Date Created : 2008/10/28
Date Issued On : 2008/11/06
PCN# : Q4084401

INFORMATION ONLY NOTIFICATION

Change Type Description: Packing Method

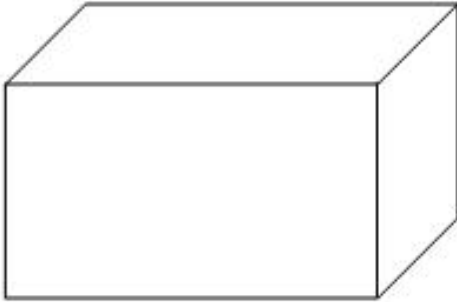
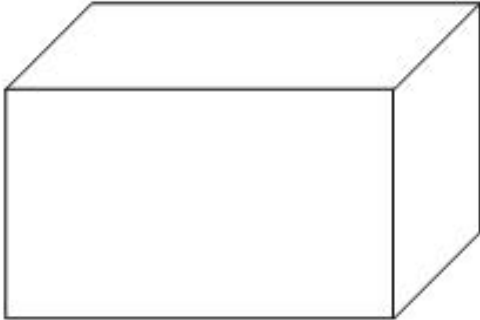
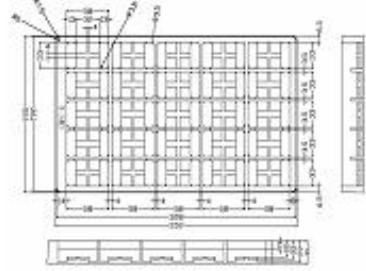
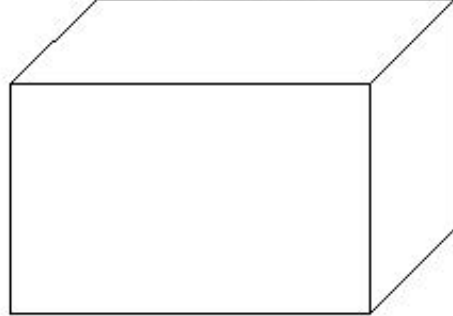
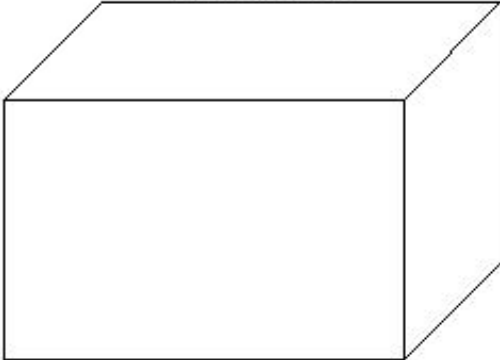
Description of Change (From): Paper box packing for GBPC(W) parts

Description of Change (To): Plastic tray + box + shrinkage film to pack the GBPC(W) parts

Reason for Change : Improve packing method to prevent lead discoloration

From	Material	Qty	Dimensions	
Tray			NA	
Box	paper	50pcs	Top Dimensions 205x205x45mm 	Bottom Dimensions 202x202x45mm 
Carton	paper	10 boxes, or 500pcs	445x215x250mm 	
Shipping Box	paper	1 carton	462x232x282mm

To	Material	Qty	Dimensions
Tray	Anti-static PS	50 pcs	<p>Top Dimensions: 332x195x18mm</p>  <p>Bottom Dimensions: 332x195x31mm</p> 
Box	paper	2 tays or 100 pcs	<p>336x200x73mm</p> 
Carton	paper	5 boxes, or 500 pcs	<p>345x215x380mm</p> 
Shipping Box	paper	1 carton	<p>372x242x415mm</p>
